CITY OF KELOWNA
MEMORANDUM

APPLICATION NO. Z07-0054

AT: 495 Keithley Road

PURPOSE: TO REZONE THE SUBJECT PROPERTY FROM THE RU1 - LARGE LOT HOUSING ZONE TO THE RU6 - TWO DWELLING HOUSING ZONE IN ORDER TO ALLOW FOR THE CONSTRUCTION OF A SECOND SINGLE-FAMILY DWELLING.

PLOT PLAN

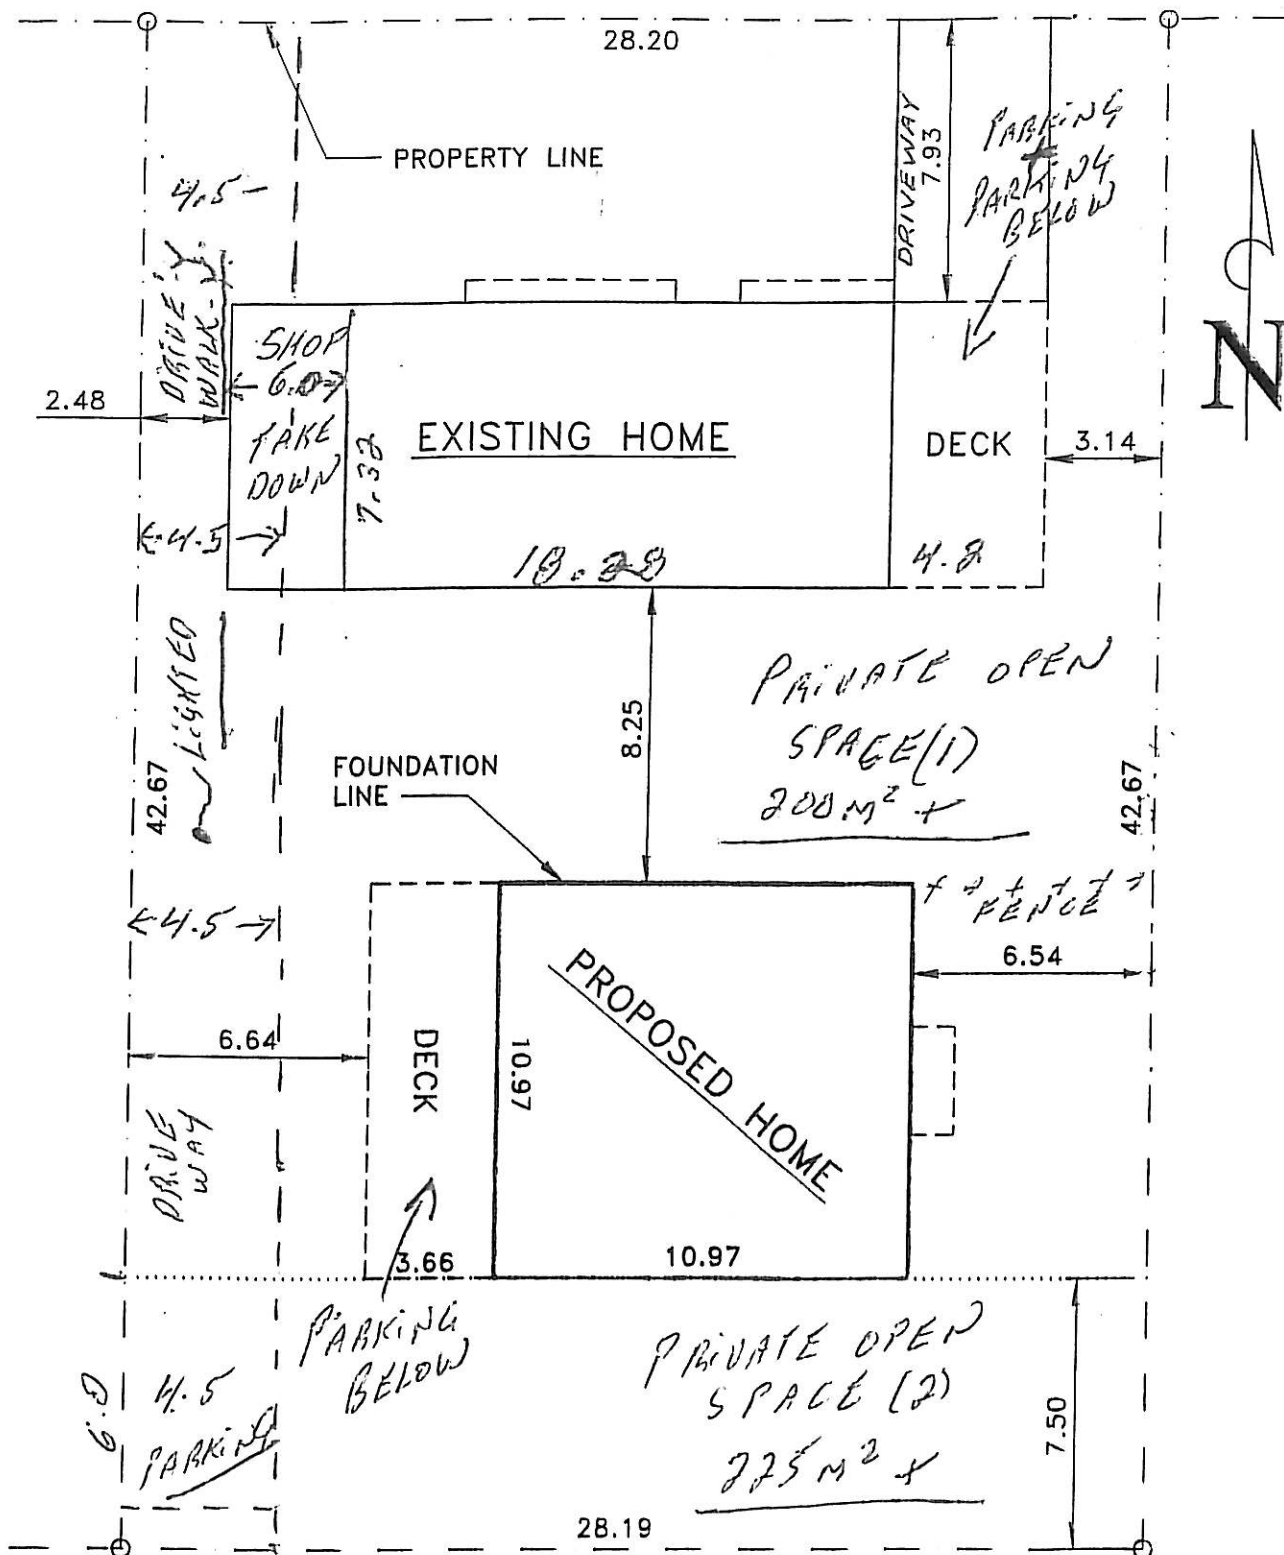
Fire department access, fire flows, and hydrants as per the BC Building Code and City of Kelowna Subdivision Bylaw. Note; Fire Department access is never from a back or side lane, it is always from the main street. Fire fighter access from the front or street side of the property to the back building(s) is not to be impeded at anytime. The address for both residences are to be visible from the street. If a fence is ever constructed between the dwellings a six foot wide gate is required. Any gate is to open with out special knowledge.

MAIN FLOOR PLAN - 1008 LINCOLN AVE.

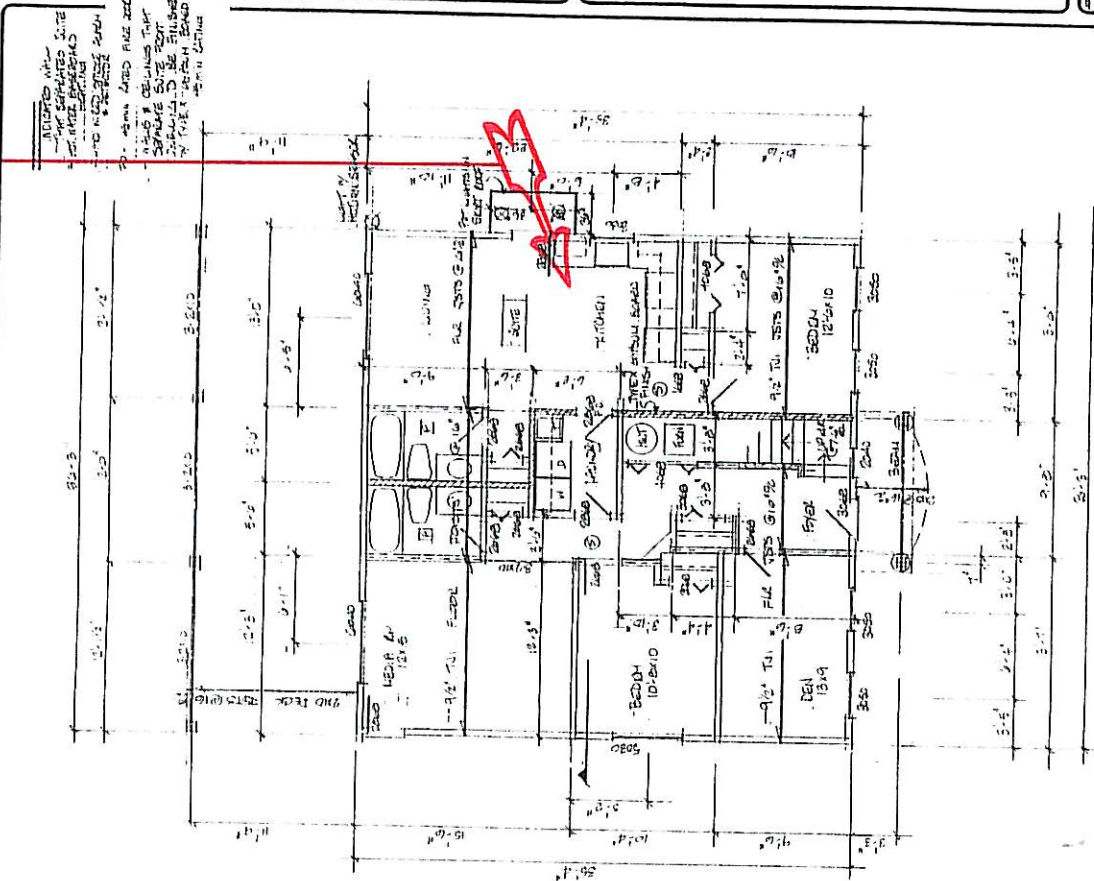
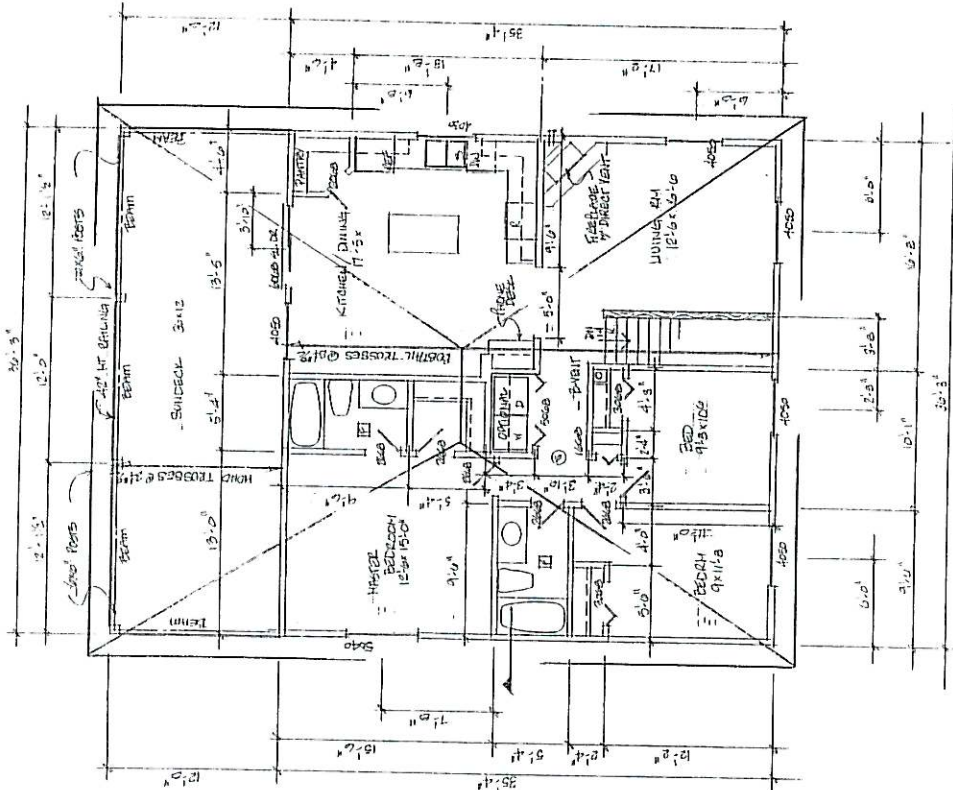
Remove second kitchen from proposed second dwelling.
